FOUNDATION INVESTIGATION REPORT

For  
Embarkment Settlements at Hwy. #58 and  
Forkes Road  
District #4, Hamilton

W.P. 78-73-01

**DECK REPLACEMENT FOR FORKS ROAD UNDERPASS**

EXISTING CROSS-SECTION

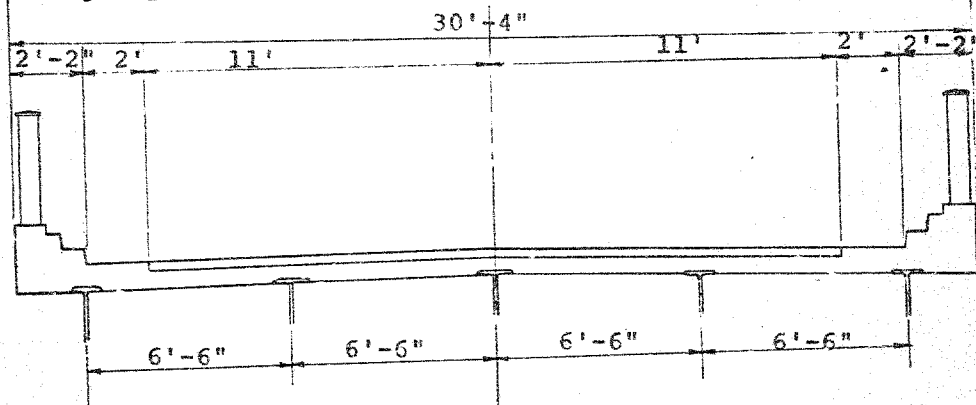
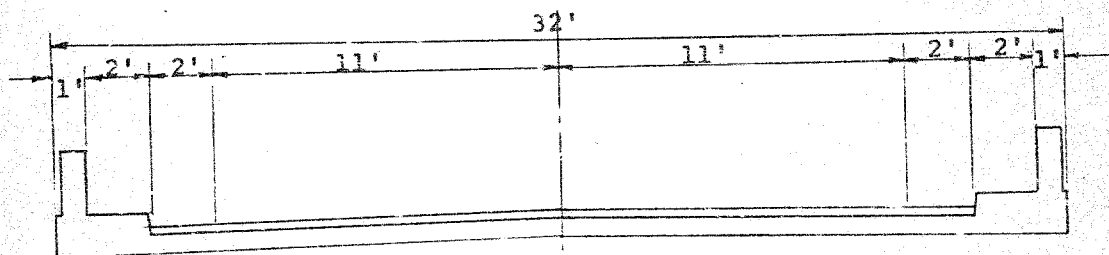
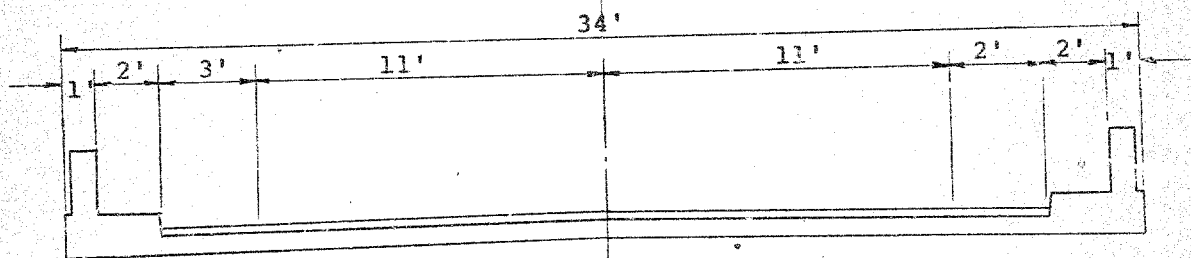
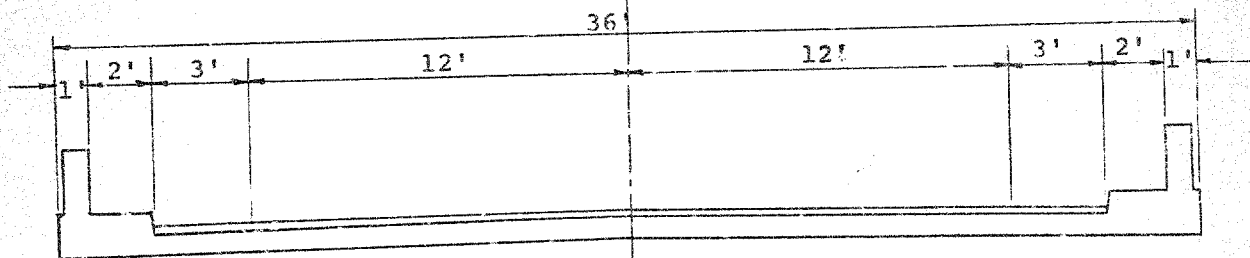
We therefore request that such a review be carried out on the existing structures and that cost estimates be prepared, based on the proposed cross-sections "A", "B", and "C" as detailed on the attached data sheet.
